RE: APPEAL OF INDEPENDENT ENGINEER REPORT FOR THE  
SUNSHARE LINDEN PROJECT  
COMMUNITY SOLAR GARDENS PROGRAM  
DOCKET NO. E002/M-19-\_\_\_\_

IN THE MATTER OF AN APPEAL OF AN  
INDEPENDENT ENGINEER REVIEW  
PERTAINING TO THE SUNSHARE LINDEN  
PROJECT AS AUTHORIZED IN DOCKET  
No. E002/M-13-867 (COMMUNITY  
SOLAR GARDENS PROGRAM)

DOCKET No. E-002/M-19-\_\_\_\_  
**XCEL ENERGY APPEAL OF  
INDEPENDENT ENGINEER REPORT OF  
DECEMBER 18, 2018**

**Figure 1: Line Upgrade Mitigations Selected in April 2017 and  
June 2017 Studies**

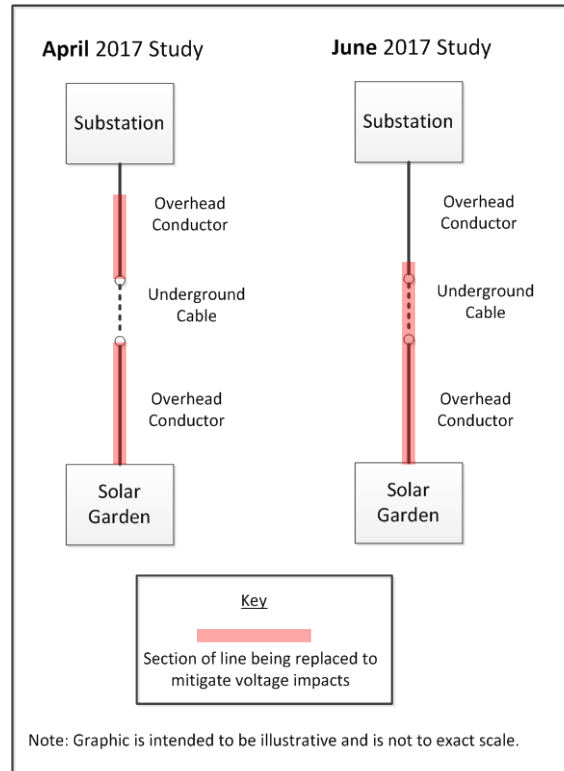
The results of the June 2017 study are correct in all material aspects, as are any diagrams and attachments included in the study report. The difference between the April 2017 study and the June 2017 study is the mitigation selected for reducing voltage impacts to acceptable limits. In the April 2017 study, the engineering consultant targeted upgrading existing overhead conductor to mitigate high voltage impacts, leaving in place a section of 1/0 AL underground cable. The amount of overhead reconductoring in the April 2017 Study (approximately 18,500 feet) caused the Linden project to exceed the \$1 million material upgrade limit. After recognizing

that a re-study was needed since the consultant did not apply the \$1 million material upgrade limit,<sup>3</sup> the Company's engineers directed the consultant to run additional scenarios where the underground cable (approximately 800 feet) was upgraded to 750 AL in order to determine if this was a more optimal scenario to mitigate the high voltage impact.<sup>4</sup> In these scenarios, steady state voltage rise was resolved and the total length of rebuild overhead line decreased to approximately 13,600 feet. Although this scenario includes a combination of overhead (13,600 feet) and underground cable (800 feet), it is the least cost option compared to a significantly longer overhead line only.

Figure 1 below shows a high-level depiction of line upgrade scenarios in the April 2017 and June 2017 studies. The June 2017 study ultimately calls for less rebuild than the April 2017 study, due to the characteristics and location of the line being replaced.

**Figure 2: Stacked Technical Constraints for the Linden Project**

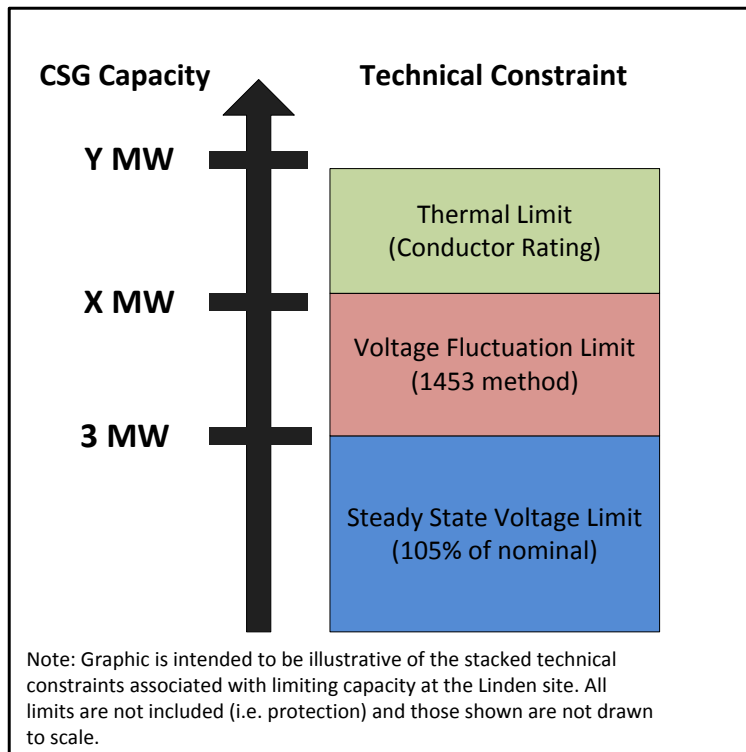
Voltage fluctuation is not a limiting factor for the Linden project: changing the voltage fluctuation threshold in a study will not change the results, since the extensive reconductoring is needed because the project causes high voltage rather than voltage fluctuation. The June 2017 study results show a maximum voltage fluctuation of 1.33%,<sup>6</sup> well below the 3% individual threshold applied based on the Company’s IEEE 1453-based approach. The 3% threshold is consistent with IEEE 1547-2018<sup>7</sup> Rapid Voltage Change limits of 3% for this project with the point of common coupling at primary voltage. Steady state voltage during light loading cases reached 105% of nominal voltage, which is the upper limit of the relevant industry standard

ANSI C84.1-2016.<sup>8</sup> Steady state overvoltage was a constraint in at least one case for every Linden project study performed to date.

In interconnection technical analysis for distributed energy resources (DER), different technical constraints are encountered as the modeled DER capacity increases. Figure 2 below illustrates some capacity limits associated with the Linden project’s interconnection for the 3 MW reconductoring case. The first limit triggered is the steady state voltage limit of 105%, which was addressed by \$1 million of reconductoring. If the program rules allowed more reconductoring, the voltage fluctuation and thermal limits would have been triggered next at a higher capacity value.
